WOODFIELD NORTHLAKE

CONSTRUCTION DOCUMENTS

COVER SHEET

SITE PLAN

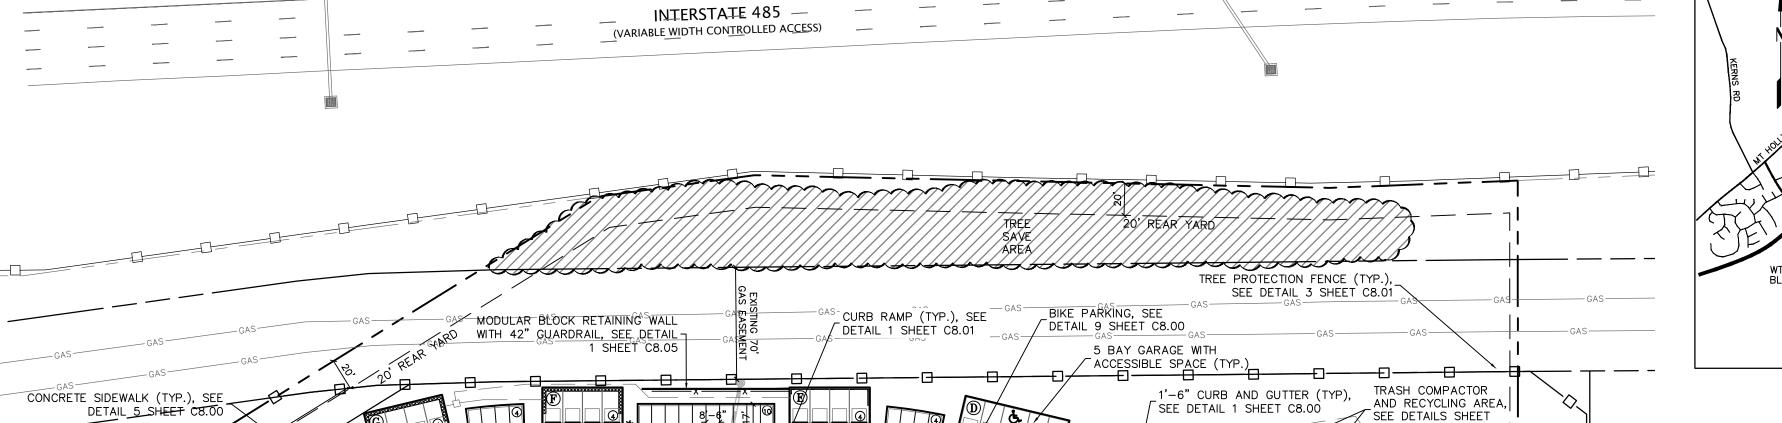
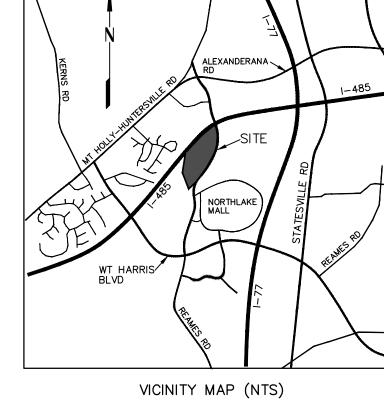
Ok, with comments, please revised

heet C7.05 (add one-way sign)
